DRAFT DEVELOPMENT BRIEF: LAND AT DOWNTON ROAD SALISBURY

This report outlines the changes made to the development brief as a result of the public consultation exercise that took place during July and August

DRAFT DEVELOPMENT BRIEF: LAND AT DOWNTON ROAD SALISBURY

Figure 6: Potential access arrangement

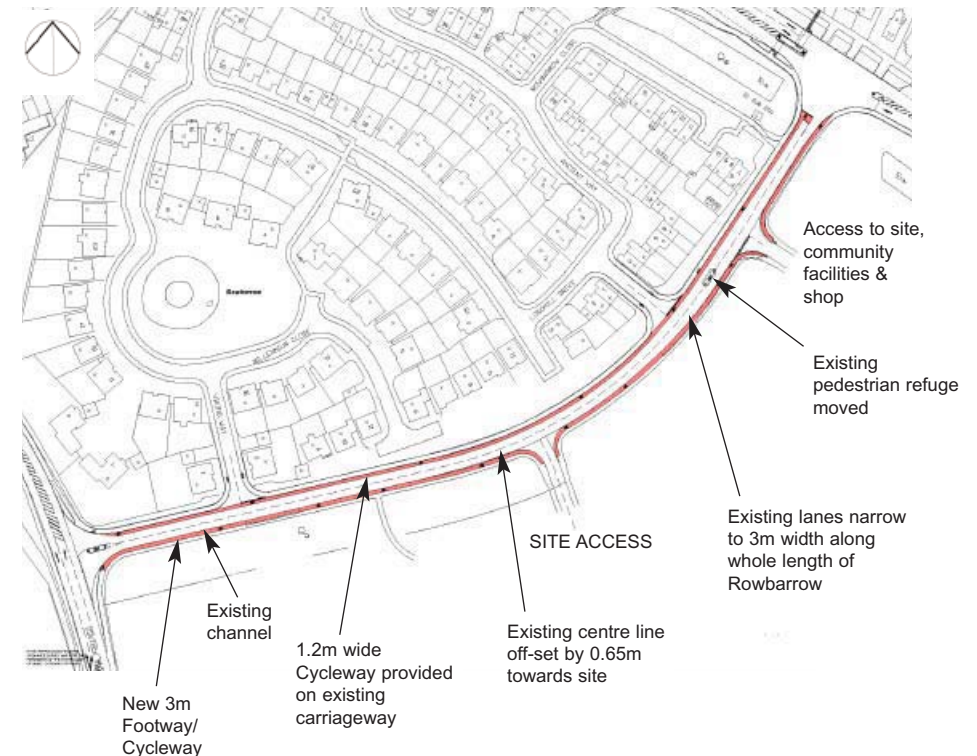
Rep No	Name	Support, Object or Neutral	Issues Raised	Response	Change made
6	Details withheld	Objection	a) 3 accesses not required b) Object to access opposite 9,10 & 11 Millennium Close c) Visible speed restrictions on Rowbarrow d) Support for the cycle path e) No need for the shop - magnet for teenagers f) Would like to see a post box g) Already play areas in the vicinity h) Keep the development discreet - don't want another Bishopdown Farm	a&b) The scheme has now been redesigned with only 2 access points as shown on the masterplan. C) Speed restrictions have been discussed with the highway authority. As Rowbarrow is an important route for access to the hospital, physical measures such as speed humps and chicanes are inappropriate. e) this is not a planning justification for there not being a shop f) This is a matter for Royal Mail g) Although there are play areas in the locality, it is only fair that the residents and children on this development have facility on the development. This is in accordance with the local plan policies h) point noted.	A & b) The masterplan has been amended to show only 2 access points

Rep No	Name	Support, Object or Neutral	Issues Raised	Response	Change made
			and will be detrimental to the value of existing properties. B) It is not acceptable to have 2 new accesses onto Rowbarrow. They should either be onto the Odstock or Downton Road. Rowbarrow is used as a short cut, with traffic travelling too fast. A speed limit on claming restrictions should be enforced.	devaluing of properties is not a planning consideration. b) Access onto Downton Road and Odstock Road is not acceptable. Access on to Downton Road would affect the tree belt and would also give rise to two junctions being close together, which would not be acceptable in highways terms. Site does not extend to enable access on to Odstock Road. Rowbarrow is not used as a short cut, it is a link road specifically designed to allow access to the hospital as well as access to the existing residential development.	
16	Details withheld	Objection	a) Concern regarding the volume and speed of traffic on Rowbarrow b) Height of the proposed buildings c) Style and quantity of the households with 1 or 2 cars each in a small area d) Number of accesses onto Rowbarrow (will be 5 with the existing 2)	a) The road is to be narrowed and cycle lanes provided. Other measures have been discussed with the highway authority to reduce speeds. These were considered inappropriate because of the importance of Rowbarrow as a through route to gain access to the hospital. B) The design of the scheme has set the buildings back from the Rowbarrow, with an area of landscaping in front. This is to lessen the impact of the buildings on neighbouring properties. c) The illustrative masterplan is in accordance with government guidance on density and will be able to meet the maximum parking guidelines. d) The scheme has now been redesigned with only 2 access points as shown on the masterplan.	d) The masterplan has been amended to show only 2 access points

- ❑ Access for vehicles is limited to direct access from Rowbarrow, the link road between Downton Road and Odstock Road forming the northern boundary of the site. There is a clear need to improve pedestrian and cycling connections between the new development and existing neighbourhoods and to connect up to strategic routes into the city and out into the local countryside. Figure 6 opposite illustrates the proposed access arrangement.

Figure 9: The current proposals for the community building

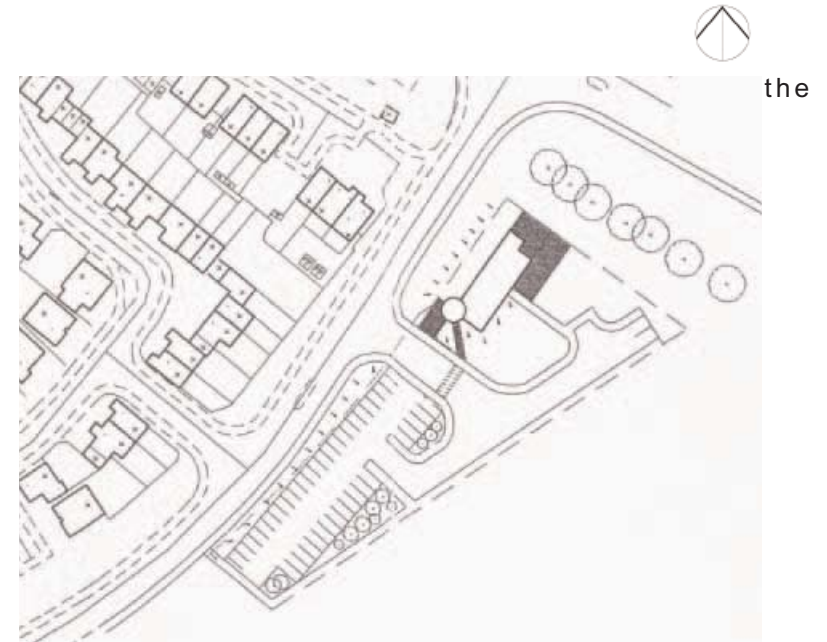
As a result of the above, the community hall has now been relocated onto where the car park for the community hall was proposed. This also has benefits to the hall, as the community association was keen that the hall has access to open land that they would be able to hold summer fetes on etc. Moving the hall to this location would meet this objective. However, although it is acceptable in planning terms to move the hall, it may still not be possible for this to be achieved. Firstly, the City area (community) committee will need to agree to the land transfer, as they are the body responsible for the existing land. If they do agree to the transfer, then because the original land transfer was dealt with under the Section 106 for Rowbarrow gardens, this will have to be amended. If for whatever reason the 106 cannot be varied then the community hall would have remain on the original site, and the shop would have to be located as near as possible to this prime site. If this were to happen, then the masterplan on the brief would be amended to reflect this and the brief would be brought back to committee for approval.

To enable the shop to be sited in the best commercial location, it may be necessary to relocate the community hall. The proposed locations of the shop and the community hall are shown on the masterplan.

For information purposes, the location of the community hall as currently approved, is shown on Figure 6.

- ☐ To enable the shop to be sited in the best commercial location, it may be necessary to relocate the community hall. The proposed locations of the shop and the community hall are shown on the masterplan. For information purposes, the location of the community hall as currently approved, is shown on Figure 9.
